**UNIVERSITY OF NEVADA LAS VEGAS**

**LIED LIBRARY FLOORING RENOVATION**

File: 007111007 UNLV AMENDMENT 6D.pln

9-12-2013

CIRCULATION DESK MILLWORK

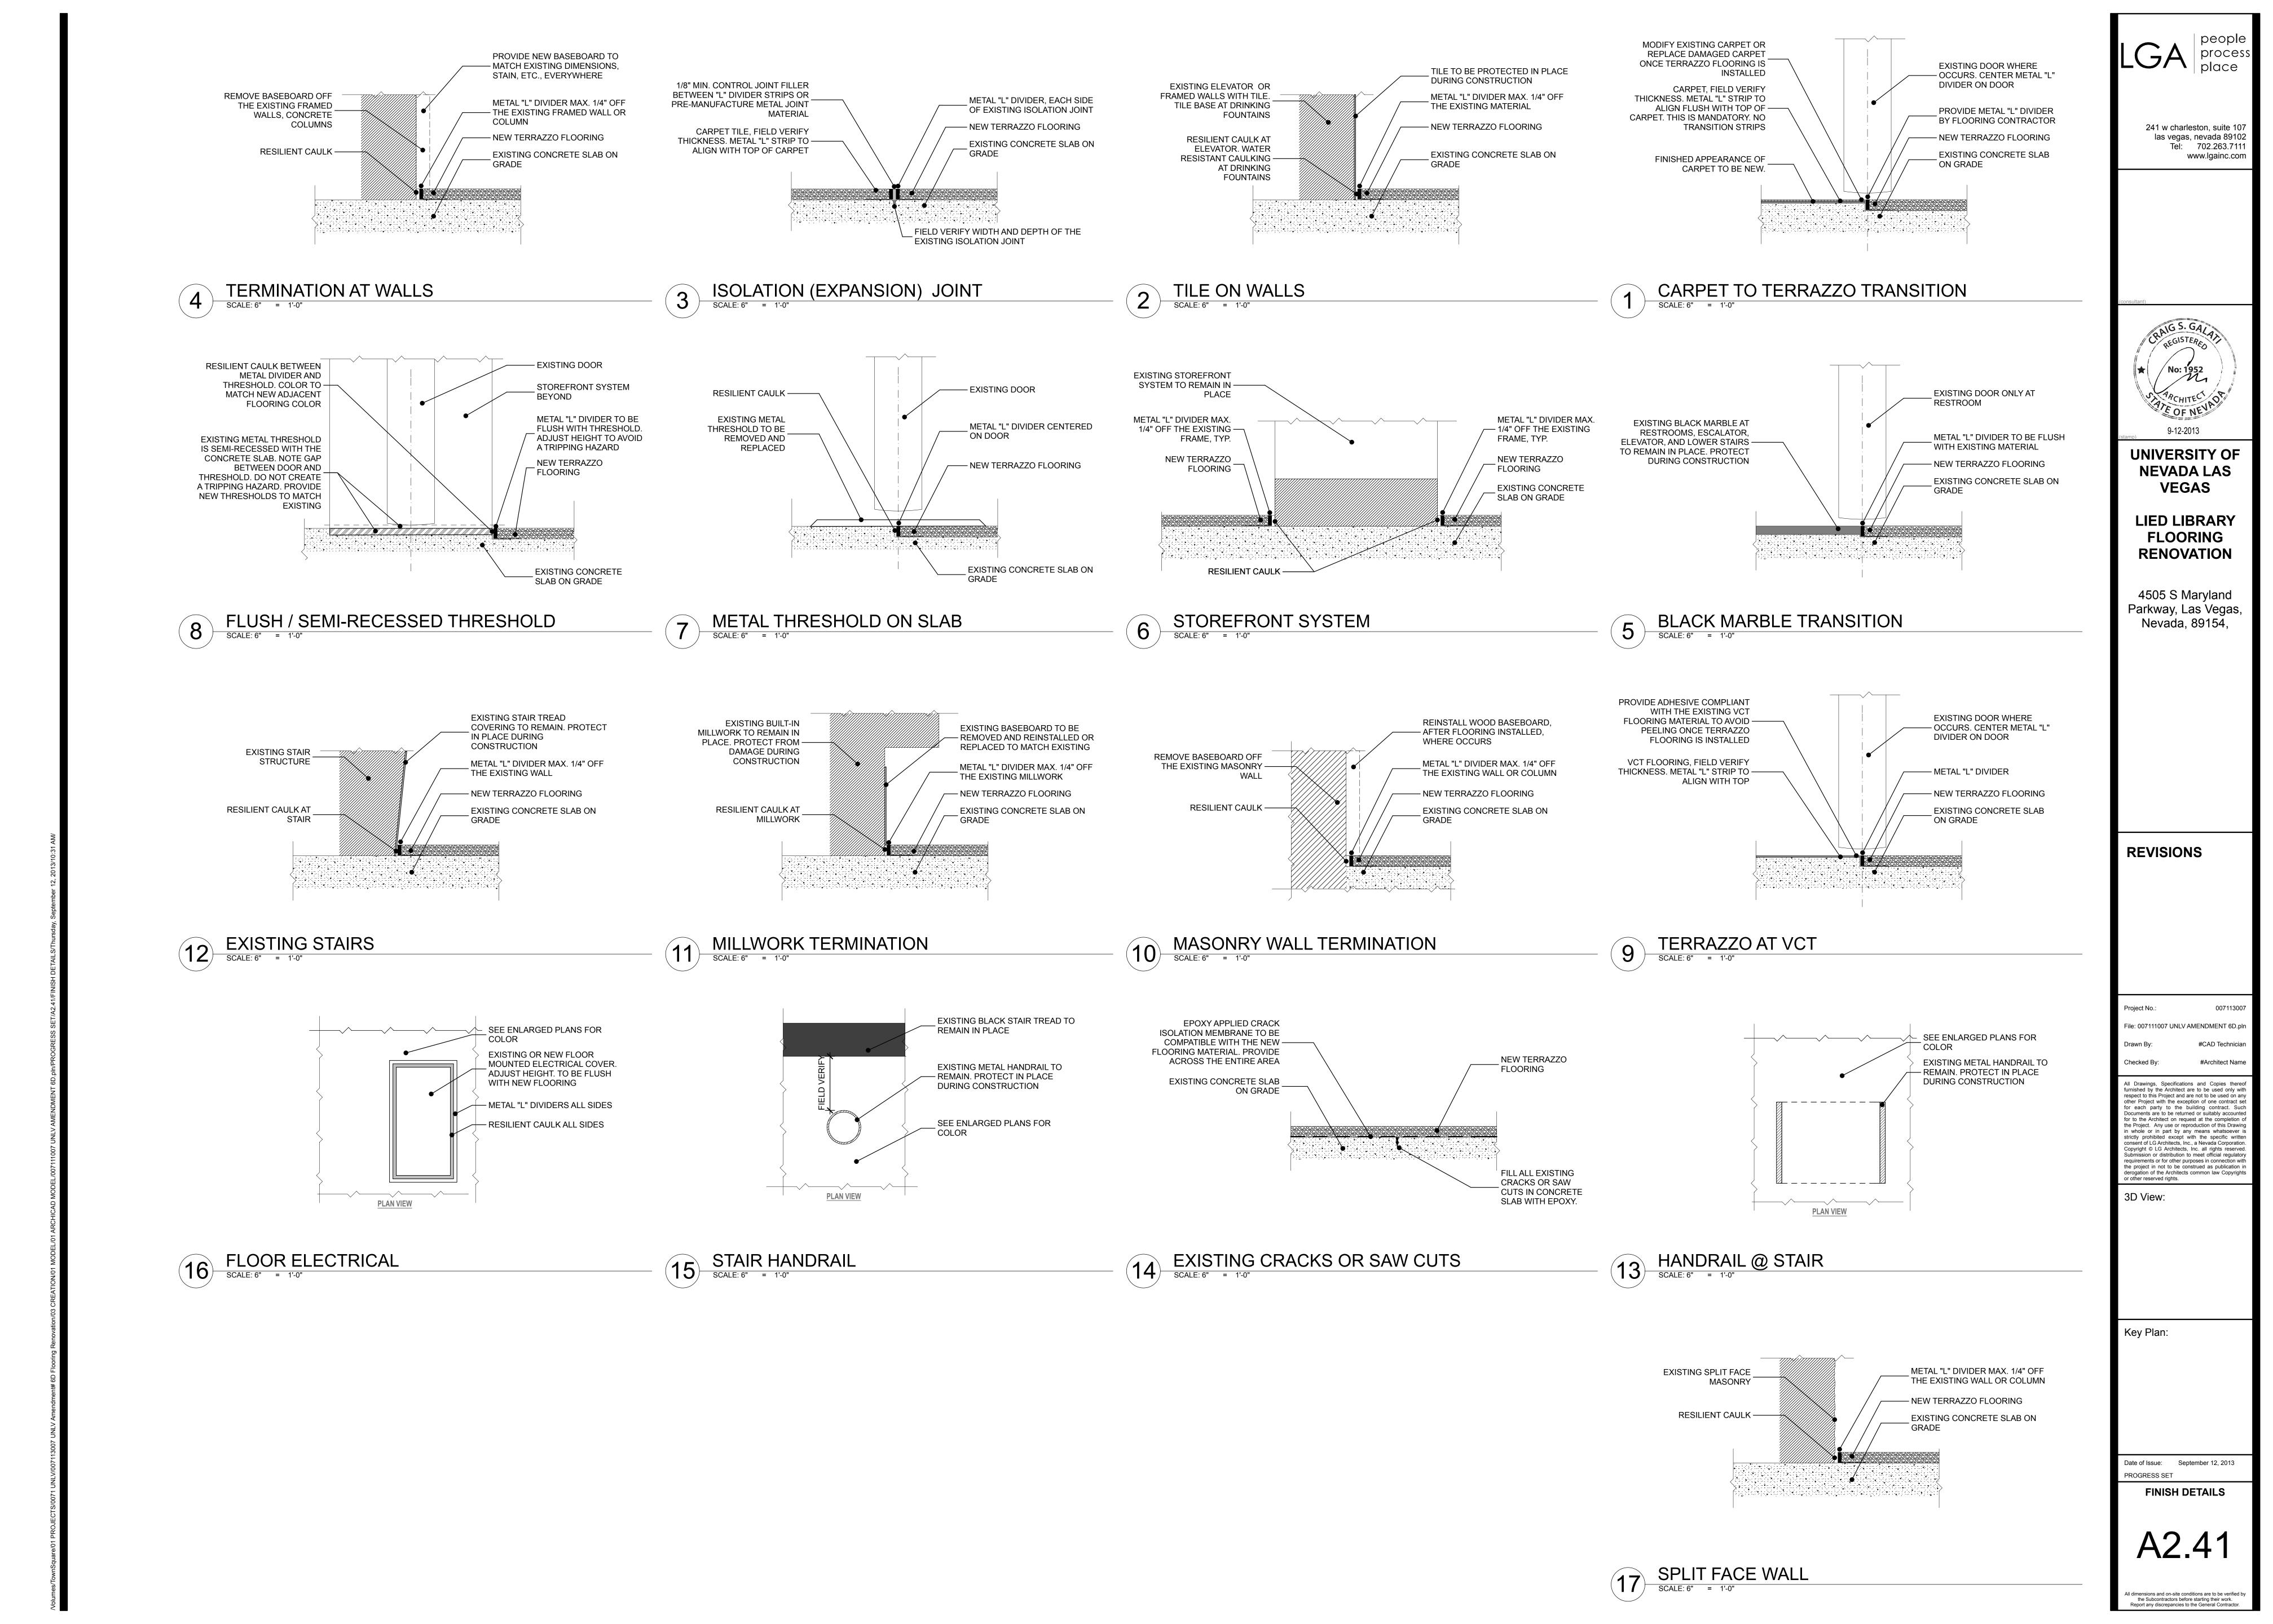
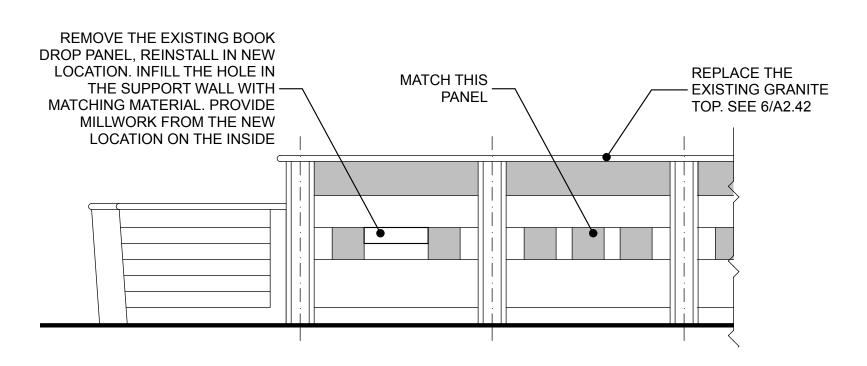
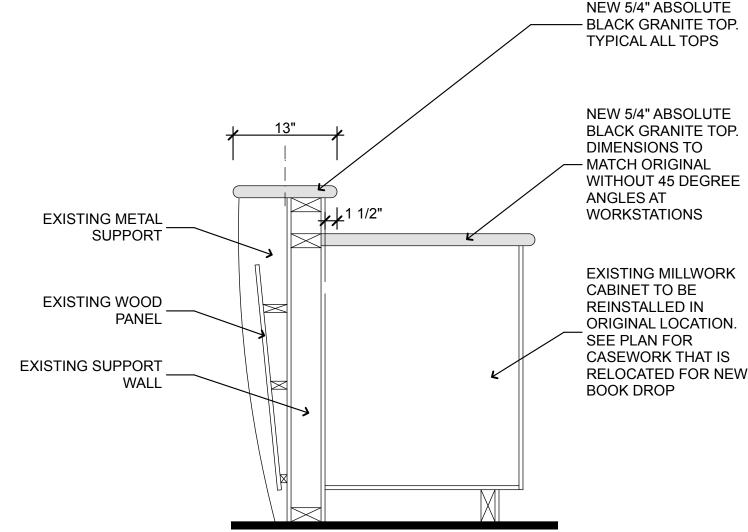
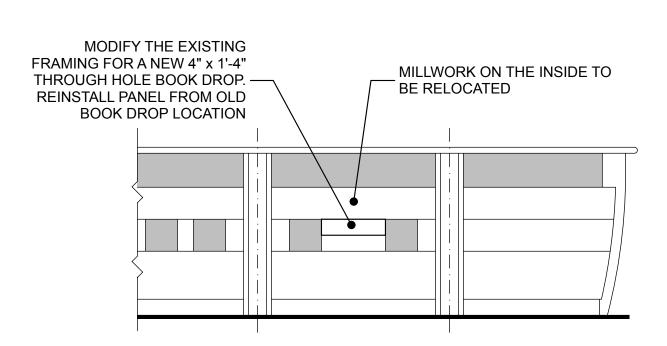
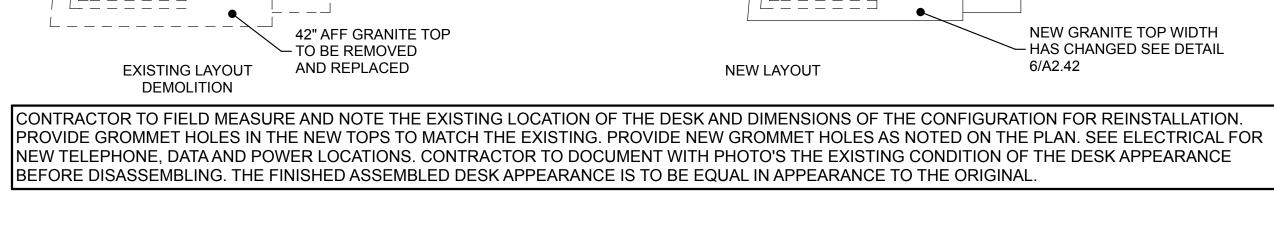
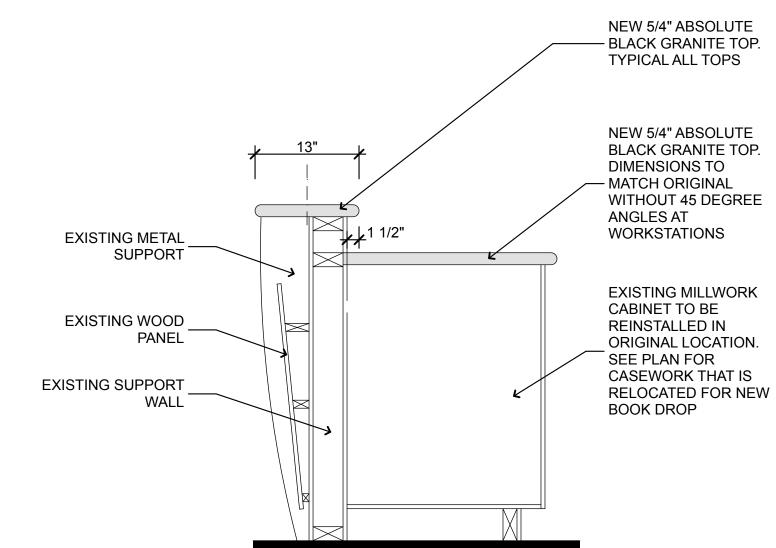
MILLWORK TO BE PROVIDE PROPER SUPPORT FOR STORED FOR - THE NEW TOP IN THE OLD - REINSTALLATION. LOWER LOWER TOP LOCATION PORTION OF TOP TO BE REMOVED ENTIRELY NEW GRANITE TOP. HEIGHT TO MATCH ORIGINAL HEIGHT 30" AFF GRANITE TOP TO **EXISTING BOOK** – BE REMOVED AND RELOCATED MILLWORK AT OLD DROP LOCATION -REPLACED - BOOK DROP LOCATION FROM NEW BOOK DROP LOCATION MILLWORK TO BE /- STORED FOR REINSTALLATION NEW GRANITE TOP. HEIGHT TO MATCH ORIGINAL HEIGHT NEW GROMMET HOLES IN TOP. COORDINATE LOCATION WITH MILLWORK FRAMING LIBRARY STAFF AND MILLWORK MEMBERS, ETC. ARE TO BELOW BE STORED FOR REINSTALLATION NEW GRANITE TOP. HEIGHT TO MILLWORK TO BE MATCH ORIGINAL HEIGHT. - STORED FOR REINSTALLATION 36" AFF GRANITE TOP TO NEW GROMMET HOLES IN TOP. ├─ BE REMOVED AND COORDINATE LOCATION WITH /<sup>⊥</sup> - - - - <sup>⊥</sup> REPLACED LIBRARY STAFF AND MILLWORK MILLWORK TO BE STORED FOR **NEW BOOK DROP** PROVIDE A 6" RADIUS AT INSIDE REINSTALLATION IN A LOCATION CORNERS, TYP. **NEW LOCATION** GROMMET HOLES IN TOP TO - MATCH THE EXISTING MILLWORK TO BE LOCATIONS — MODIFIED AND REINSTALLATION NEW GRANITE TOP WIDTH

- HAS CHANGED SEE DETAIL

6/A2.42
